## Department of Energy

Environmental Management Advisory Board  
Tank Waste Subcommittee (EM-TWS)

**SUMMARY REPORT -  
HANFORD WASTE TREATMENT PLANT**  
SEPTEMBER 15, 2010

**EM Tank Waste Subcommittee Report for Waste Treatment Plant**

Figure C-2. Comparisons of design wear allowances to the predicted 40-year wear (24590-WPT-RPT-PET-08-008, Rev. 0)

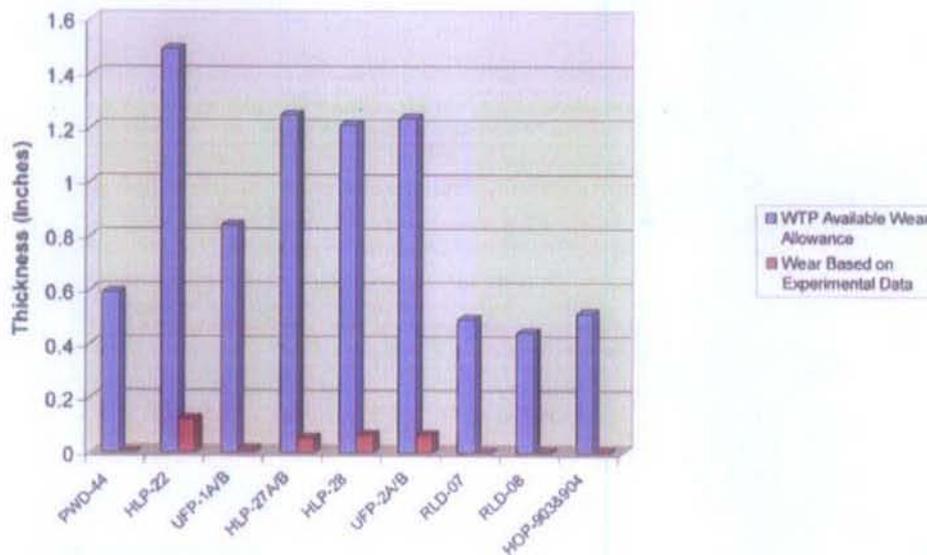
This issue was resolved by performing tests that verified that the curve used (Figure C-2) was a conservative estimate of erosion. Although run with simulants, these tests should provide a reasonable basis for closure of this issue. However, it was acknowledged that the largest particles cause the wear and the effect is highly non-linear (Page 6 of 24590-WPT-RPT-PET-08-008, Rev. 0), but only the weighted average particle size was used as the parameter to validate the test slurry. It appears that this had no significant effect since the wear curve used for design was still more conservative than that representing the largest particles used in these tests (54 microns).

The use of pre-qualification testing to characterize individual batches for erosion is a significant advantage to the program. Tests to determine the average weighed particle size of any incoming batch need to be conducted as part of this characterization program. The results of these tests can be turned into a running tally of expected wear in each tank based on the actual feed percentage and size.
